Design Review Board Meeting
Tuesday, August 26, 2025 - 5:30 PM
AGENDA

PLANNING STAFF REPORT

APPLICATION XX-XX-XX | CERTIFICATE OF APPROPRIATENESS

Request: To conduct exterior improvements – façade, electrical, and window replacements on the building at 67 S Main Street.

HISTORIC PHOTO FOR REFERENCE

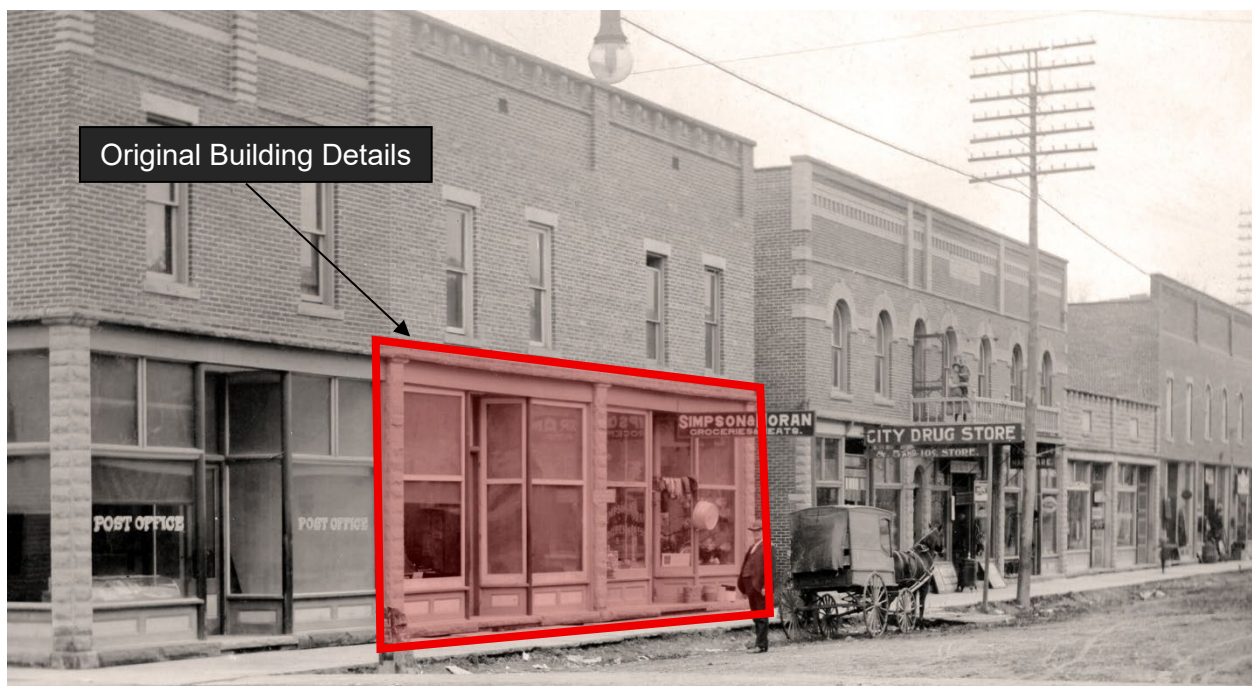
Reviewer Comment: While the proposed alterations bring the building closer to its original form, the proposed storefront system will leave the front of the building flat against the sidewalk with no recesses for primary entryways, or details along the bottom of the windows as were originally included (see photo on page 3). Given the adopted design guidelines call for "Decorative metal framing systems with an exterior-grade finish system", the applicant could explore a storefront framing system, or other material choices, that includes decorative

elements near the bottom of the façade, similar to the original building details, and to recess the front doors to create additional dimension within the façade. These two changes will bring the majority of the original character of the building.

Reviewer Comment: Many of the original details along the ground floor have been removed by previous alterations. The photo on page 3 illustrates the original ground-floor details on this structure.

Reviewer Comment: The proposed storefront system lacks the details originally exhibited on this building. Using a revised storefront system or blending other materials with the storefront system is an opportunity to restore much of the original character of this building.

While the proposed alterations restore much of the original character, the reviewer has identified two changes that would add additional historic detail that was formerly present on this building:

1. Recess the entryways to mimic the original front doors as illustrated in the photo below.
2. Utilize a different storefront system that includes details along the bottom of the windows, or utilize differing building materials to add detail below the proposed storefront system.
